**FINDINGS AND RECOMMENDATION
OFFICE OF PLANNING AND ZONING
ANNE ARUNDEL COUNTY, MARYLAND**

CASE NUMBER: 2024-0216-V

The applicants are requesting a variance to allow dwelling additions (one-story screen porch, living space, covered porch, balcony, deck and steps to grade) with less setbacks than required, disturbance to slopes of 15% or greater, new lot coverage nearer to the shoreline than the principal structure, and that does not comply with the designated location of a principal structure on a waterfront lot on property located at 115 Boone Trail in Severna Park.

EXISTING CONDITIONS & ENVIRONMENTAL RESOURCE PLAN
VARIANCE PLAN
LINSTEAD ON THE SEVERN ~ LOT 56
115 BOONE TRAIL, SEVERNA PARK, MARYLAND 21146
TAX ACCT. NO. 03-490-26074898
TAX MAP 31 GRID 18 PARCEL 84 DISTRICT 3RD
ANNE ARUNDEL COUNTY, MARYLAND

DEVELOPED CONDITIONS PLAN
 VARIANCE PLAN
LINSTEAD ON THE SEVERN ~ LOT 56
 115 BOONE TRAIL, SEVERNA PARK, MARYLAND 21146
 TAX ACCT. NO. 03-490-26074898
 TAX MAP 31 GRID 18 PARCEL 84 DISTRICT 3RD
 ANNE ARUNDEL COUNTY, MARYLAND

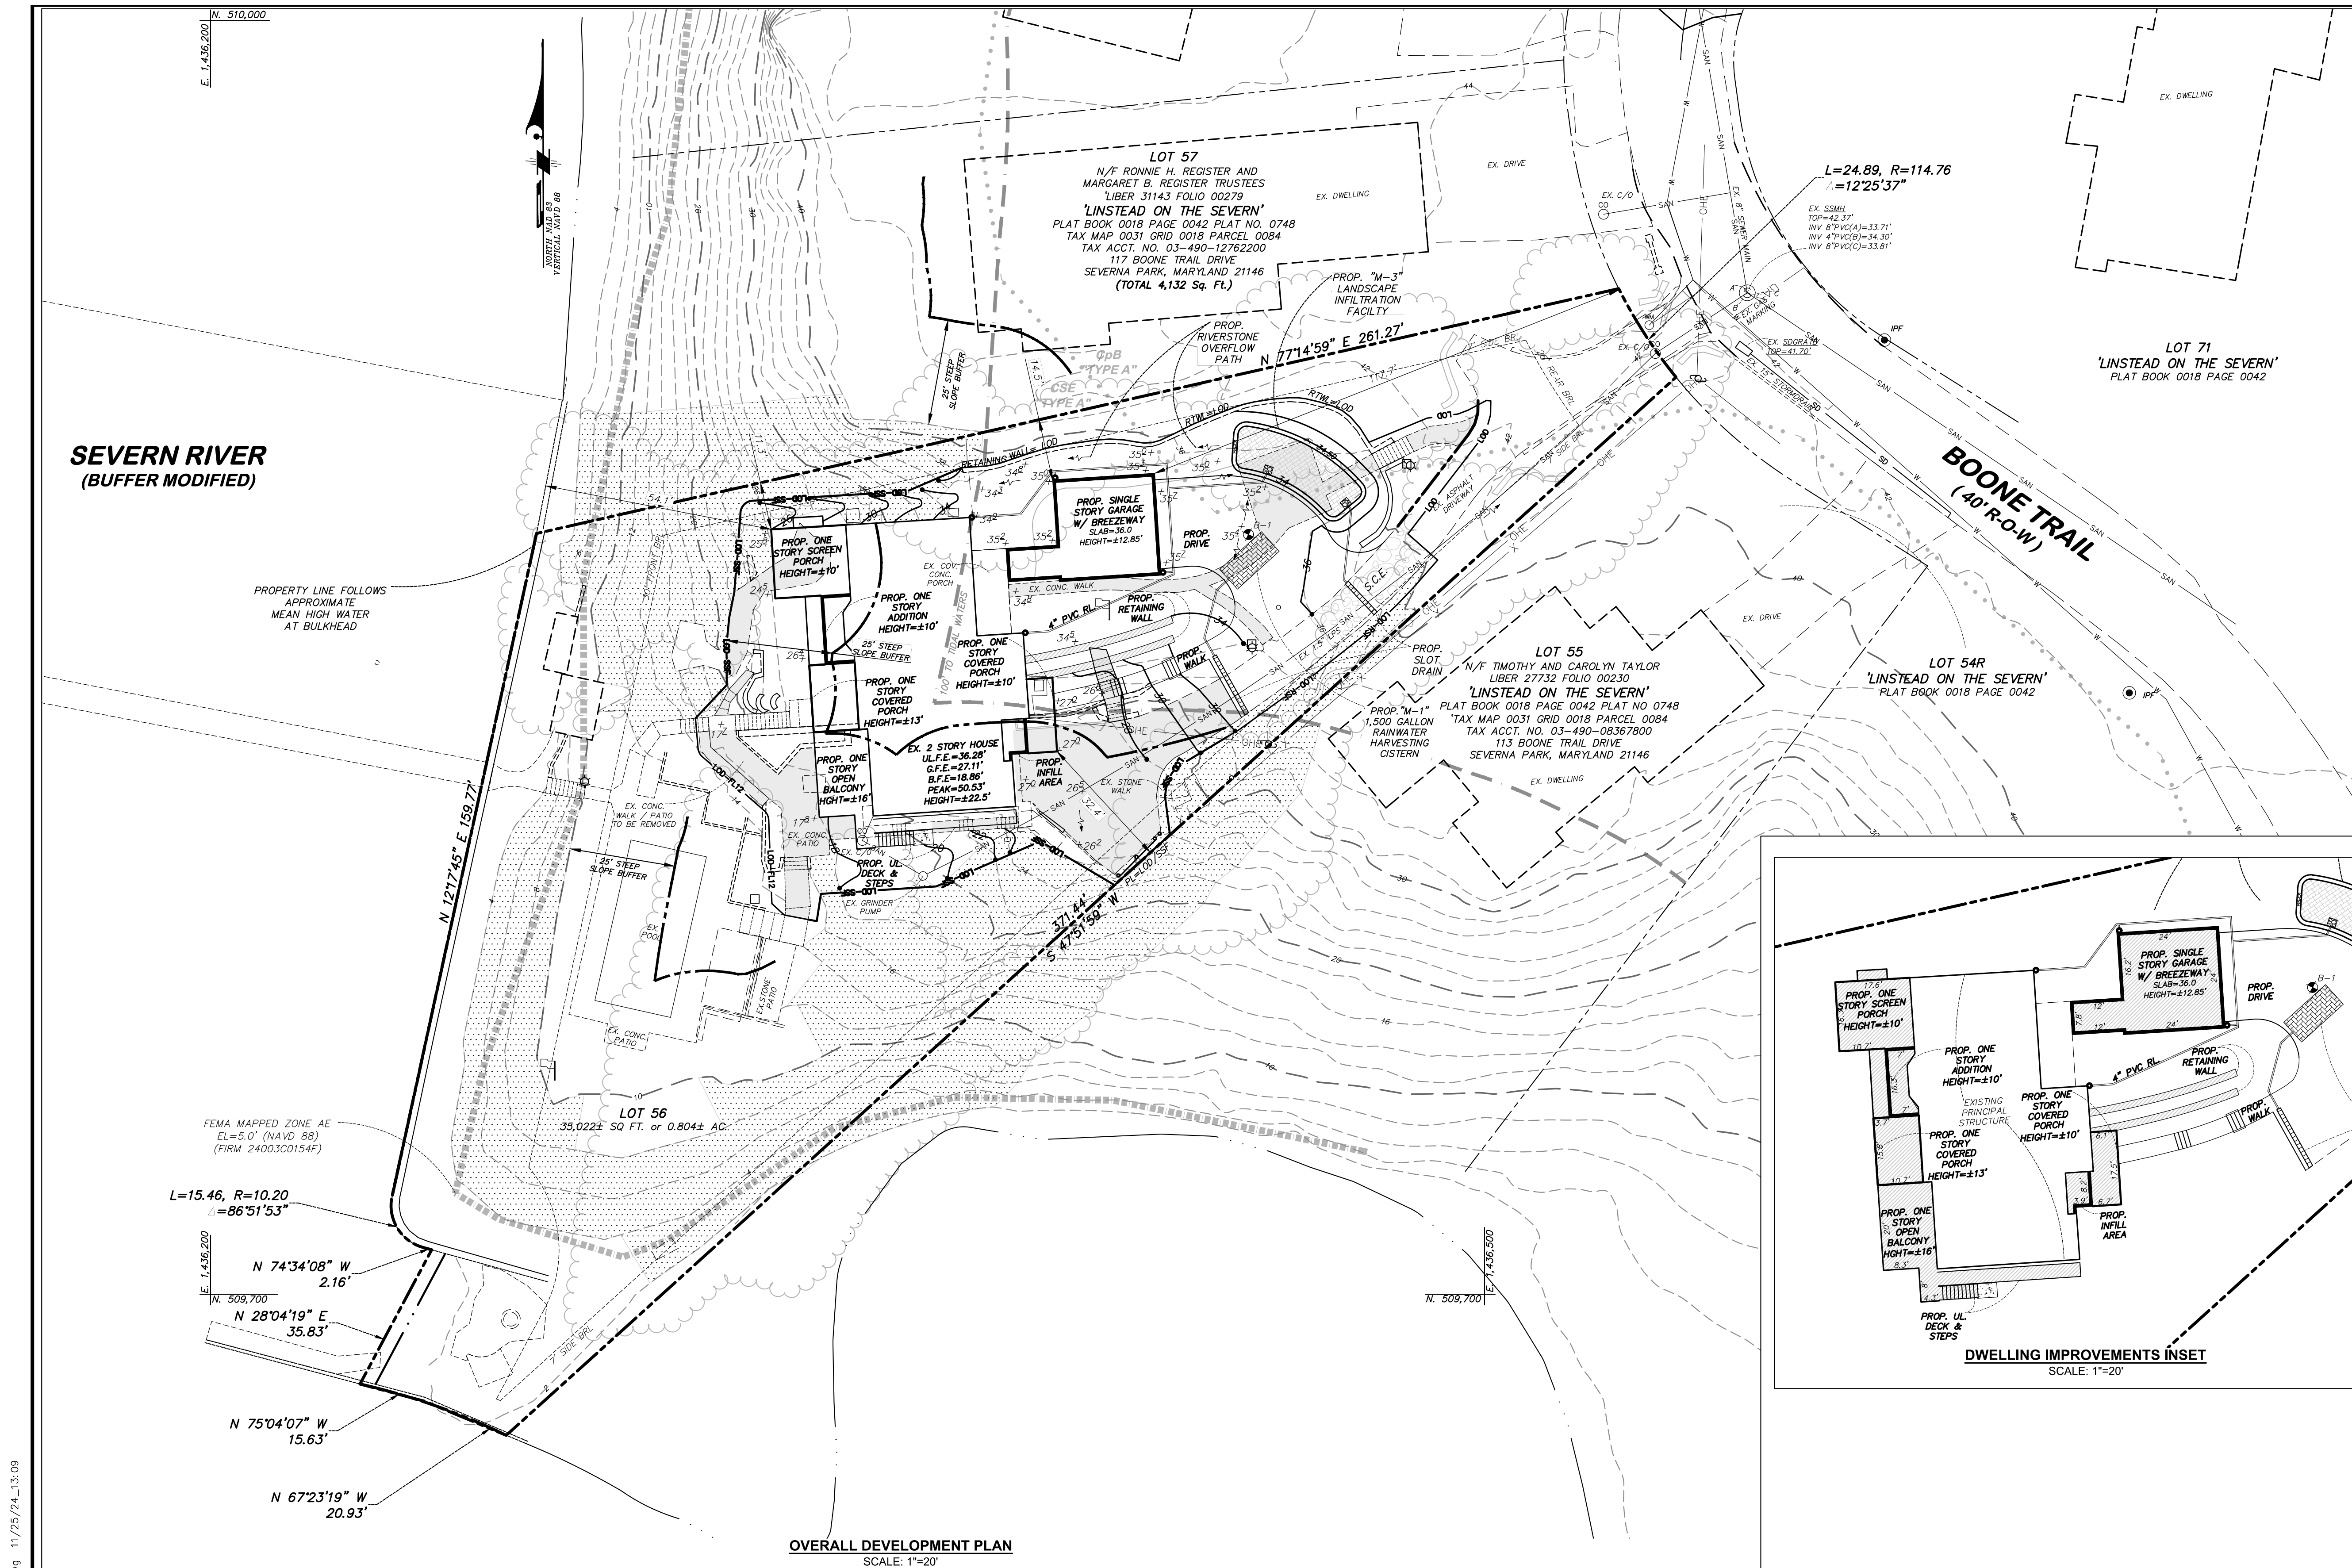
2. A rainwater harvesting cistern is proposed for this project. How is the water re-used and show the area of the dedicated use? For example, if the water is used for irrigation purposes, we need to call out the area on the plan and it should be a dedicated use. The water shall not cause downstream flooding or nuisance flooding to neighboring properties.

3. The proposed rainwater harvesting cistern operation and Maintenance details, typically from the manufacturer, shall be added to the plan. Generic details from the state manual should be evaluated and revised if they do not apply to a particular system.

4. The proposed rainwater harvesting cistern details of the pipes and irrigation (if that is the dedicated use) should be on the plans for the benefit of the inspector and owner.

5. The proposed landscape infiltration and underdrain pipe underneath the driveway and sidewalk should be revised - this office is concerned with the potential maintenance issues a homeowner would face given the driveway and utility connections. How is the maintenance handled if the underdrain is clogged or needs to be replaced?

7. Please review existing vegetation (or lack thereof) within the steep slopes; opportunities to supplement vegetation or replanting buffers with native vegetation should be reviewed and provided to enhance water quality.

8. Provide a qualified professional review of the condition of suitability steep slopes; ensure the proposed improvement including quality and other limits do not adversely impact the intensity of the slope and can cause slope failure.
